AGENDA

a. DR-26-08 - 217 North 2nd Street Residence – ACTION ITEM

b. **DR-26-09 – Addition to 213 North 3rd Street – ACTION ITEM**

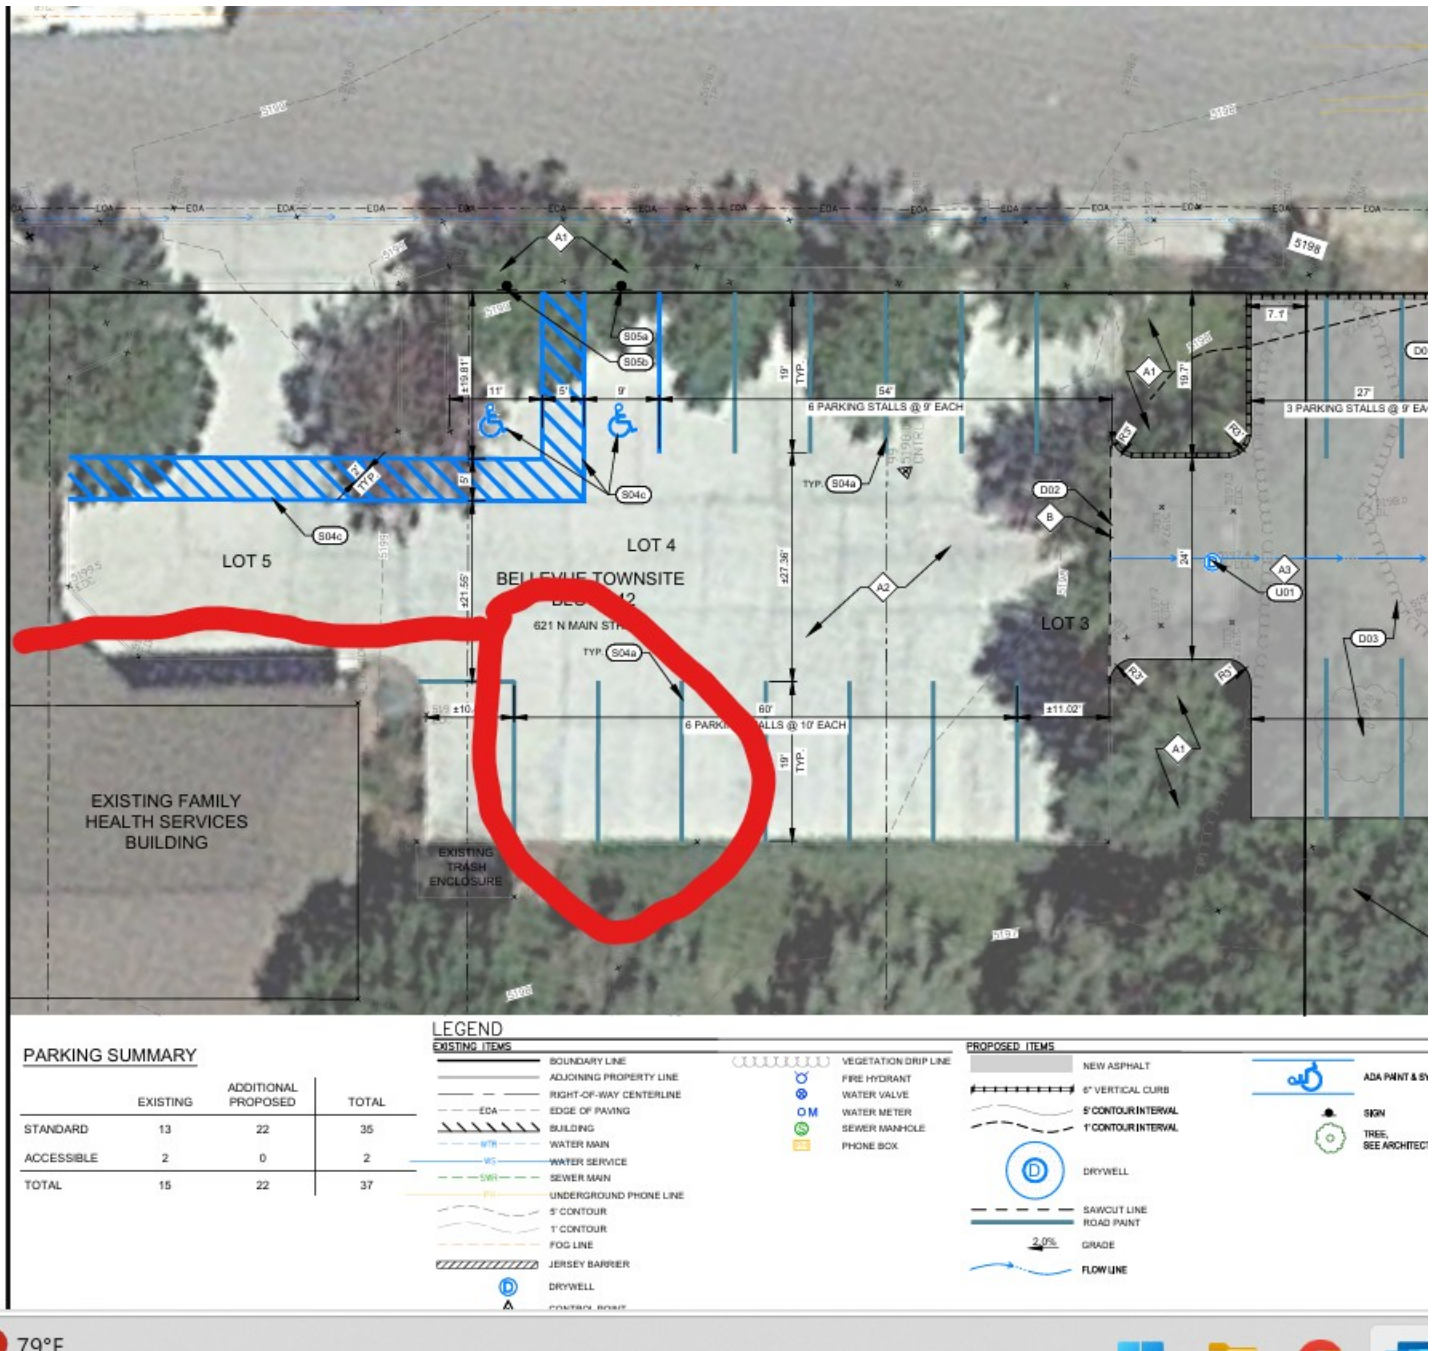
I did do a quick look at the plans and have a couple of comments as follows-

I would prefer the accessible parking spaces and access aisle be move west across the lot to keep the users from having to cross the vehicular way to get to and from the accessible building.
